North East Link Eastern Freeway Upgrades – Urban Design and Landscape Plan (UDLP)

Manningham Council Submission

27 October 2023

Figure 1 – Streetview image showing the view from Marjorie Close looking south towards the existing freeway noise walls.

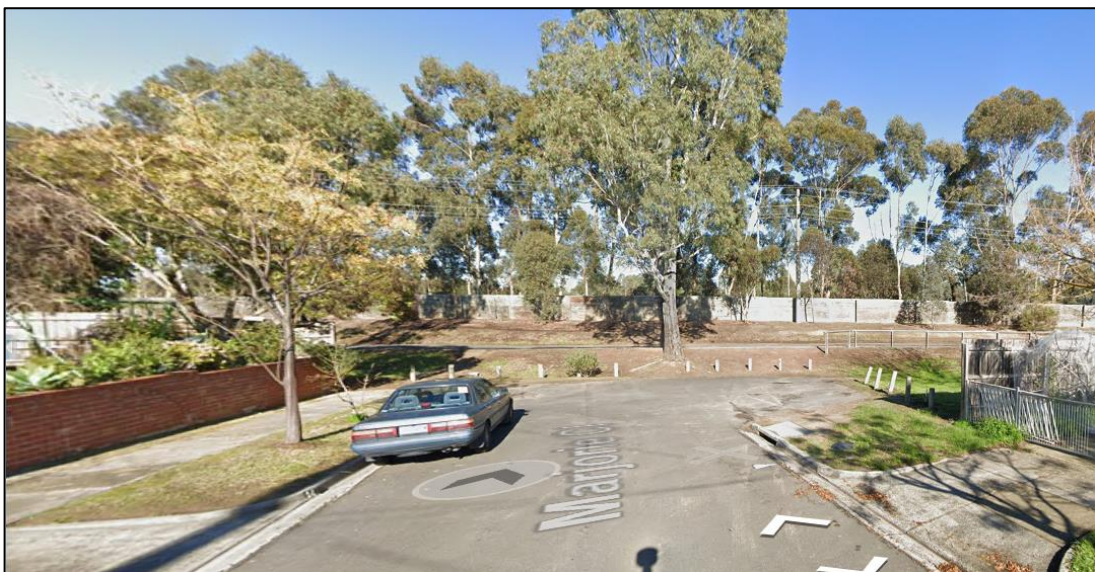
28. The vegetation here is limited to a single tree as shown in Figure 1 above, and this land is already included in the project boundary. There is therefore clear capacity for a link to be provided, which would significantly improve connectivity for Marjorie Close residents and other members of the community accessing the SUP or surrounding open space from this location.

Figure 3 – Excerpt of UDLP Attachment 1, Part 1, page 17 (drawing 9028) showing Council's recommended additional crossing point (green arrow) at Doncaster Road / High Street intersection.

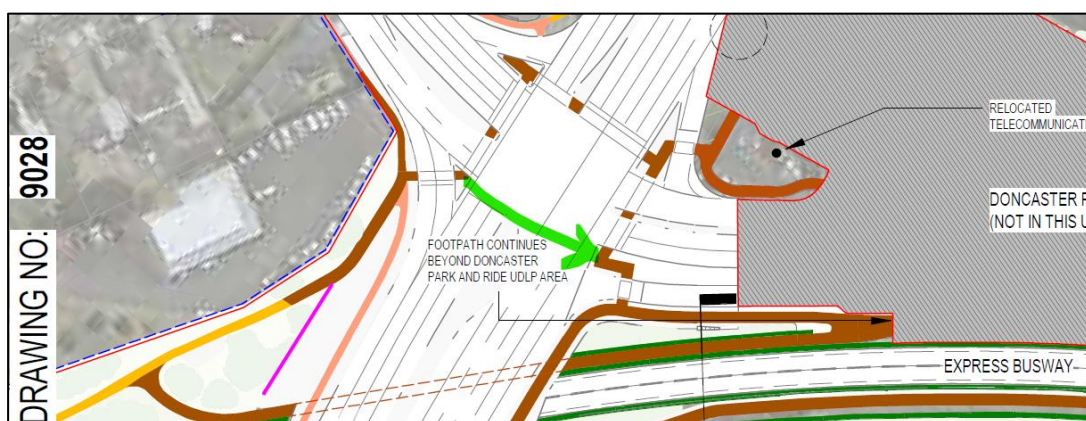
36. Council's position is that an at-grade pedestrian refuge and signalised crossing is required on the southern side of the Doncaster Road / High Street intersection. Pedestrians seeking to access the Doncaster Park & Ride from the south side of High Street must first cross to the north side of High Street, and then cross again to the east side of Doncaster Road. Alternatively, they can take an indirect route via the proposed underpass.

37. This is an inefficient and inconvenient outcome that may lead to illegal 'Jaywalking' and subsequent serious safety concerns. Additionally, provision of a signalised crossing over all main lanes of traffic is a common and standard outcome for intersections of this type and size.

38. Council submits that this additional crossing should be provided as part of this current UDLP to enable its construction at the same time as the Doncaster Road Interchange upgrade – which includes the other signalised pedestrian crossings at the High Street / Doncaster Road intersection.

45. Council seeks further clarification regarding the noise wall shown at Doncaster Road Interchange on the west side of Doncaster Road, south of High Street (shown in pink in Figure 3). There are no private residential interfaces in proximity to this wall, and it may create a visual barrier to the shared user path and limit passive surveillance. As such, its height should be minimised, or its location reconsidered.

Figure 4 – Excerpt of UDLP Attachment 2, Part 1, page 24 (drawing 9530) showing the location of Cross Section 03 - which is taken through the existing path rather than the wider SUP and does not show the interface with the Soccer pitch.

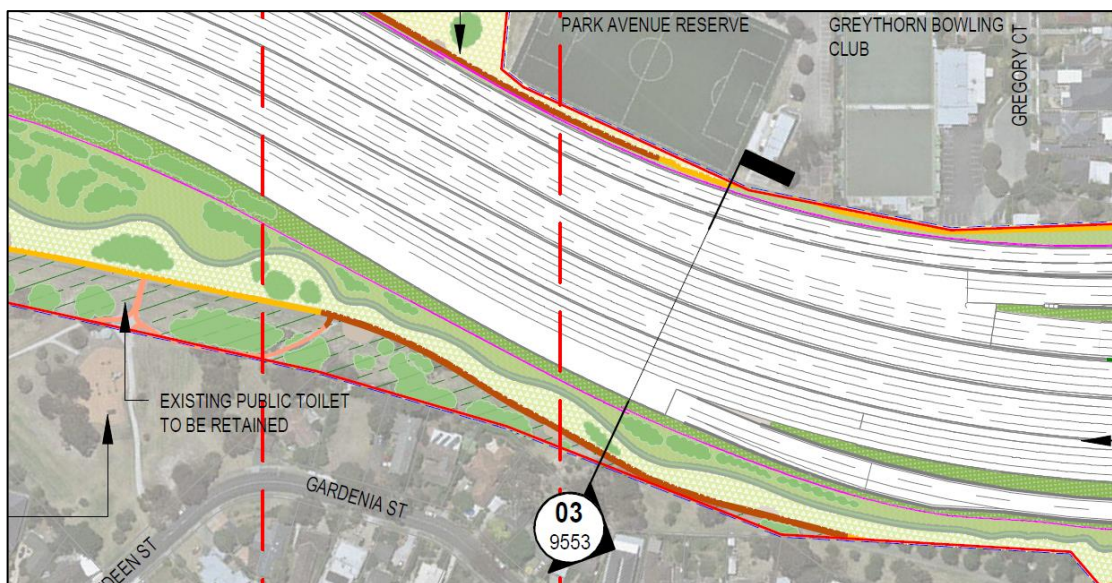
51. Further work should be undertaken in consultation with relevant stakeholders for Park Reserve during the detailed design stage, to ensure impacts as a result of the project are mitigated, and that opportunities for upgrades are maximised.
52. In particular, the loss of spectator space on the south side of the reserve due to the widened freeway and new SUP should not be worsened by the introduction of freeway lights, landscaping at maturity, or any other features that arise at the detailed design stage.
53. Council encourages NELP to support and assist impacted facilities and clubs with future upgrades, to offset the impacts as a result of the project. It is noted that the North East Link Community Fund is set up with this in mind, and that round 3 applications for this funding will open in 2024.

Figure 6 – excerpt of UDLP Landscape Plan for Zone 7 showing the current access to the Scout Hall via a red arrow.

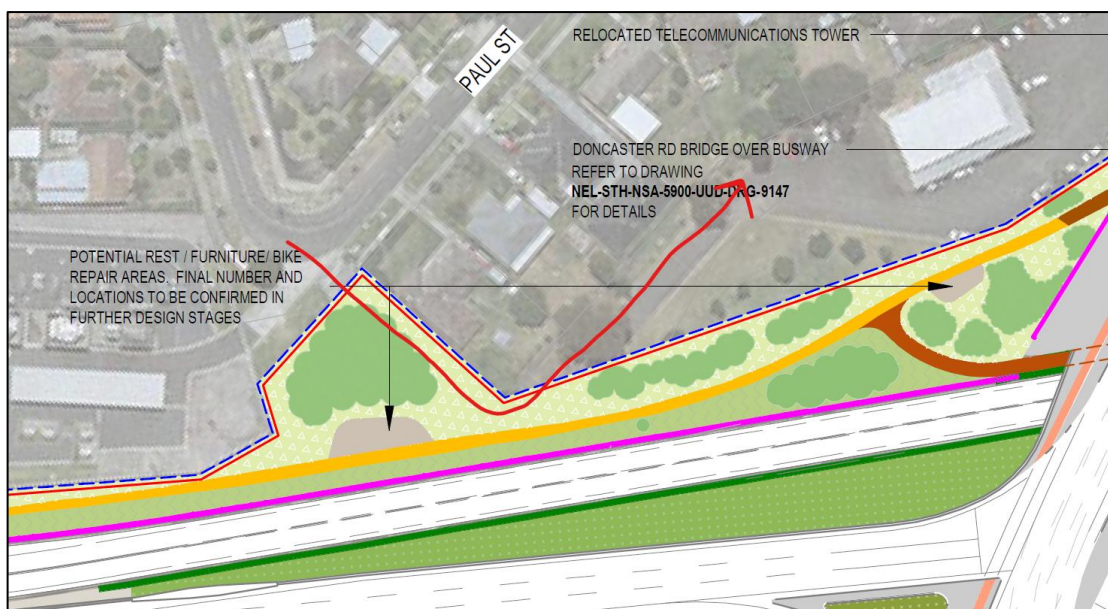
82. Council notes that providing sufficient accuracy in all UDLP drawings is integral to ensuring transparency for all stakeholders including the Manningham community. It is recommended that a careful review of all drawings be undertaken before the final UDLP is submitted for approval.
83. Of note, is that the landscape plan for 'Zone 7' (UDLP attachment 2, part 2) shows landscaping covering an access road that connects from Paul Street in Doncaster to the carpark of the Tende Beck Scout Hall. No other access arrangements are available for this facility. It is therefore expected that this drawing will be reviewed and corrected.
